Below you will find the latest information that is important to know when bodybuilding on a Scania vehicle.

360° 3D/2D AREA VIEW CAMERA IN SMART DASH

CUSTOMIZED MESSAGES FOR BODYBUILDERS – CHARACTER AND SYMBOL DISPLAY LIMITATIONS

NEW JUMP START CONNECTOR POSITION FOR BEV CHASSIS

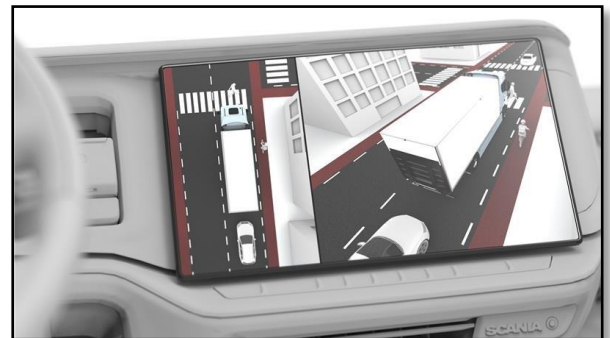
Scania is introducing an updated 360° Area View Camera System for chassis with Electrical System Generation 7 (FPC9742B), available with **FPC9026A (with external monitor) or as spare part number 3264979 (without external monitor)**. The system is designed to give the driver a better overview around the vehicle and support safer manoeuvring in demanding environments such as urban traffic, distribution, construction sites, and tight loading areas.

The system can show a 3D view directly in the Central Information Display (CID) and can also use the GSR rear camera as part of the camera setup. For applications requiring a larger display, a 10-inch monitor can be added. Depending on the driving situation and programming, the system can automatically show relevant views, such as a top view around the truck, a rear view when reversing, split-screen views, or side views when the left or right indicator is activated.

FPC9026A (with external monitor) will come with all parts needed to remove the monitor and route the video out to Digital Driver Interaction Control Unit (DDU) if customer wants the system displayed in the CID instead.

Object detection **part number 3268393** can also be connected to the Scania camera system. The function is pre-set to detect pedestrians and cyclists, and it can be programmed to detect other objects such as cars and buses. This gives the driver additional support in situations where vulnerable road users or other vehicles may be close to the truck.

For customers who need recording functionality, the system can be combined with a DVR box to record camera views. For recording, **MDVR 4 channel part number 3156665** is used. If all camera channels should be recorded, **4 pieces adaptor part number 3293779 are needed**. If the GSR camera is used in the 360 system, the required adaptors are **3 pieces adaptor part number 3293779** and **1 piece with part number 3293792**.
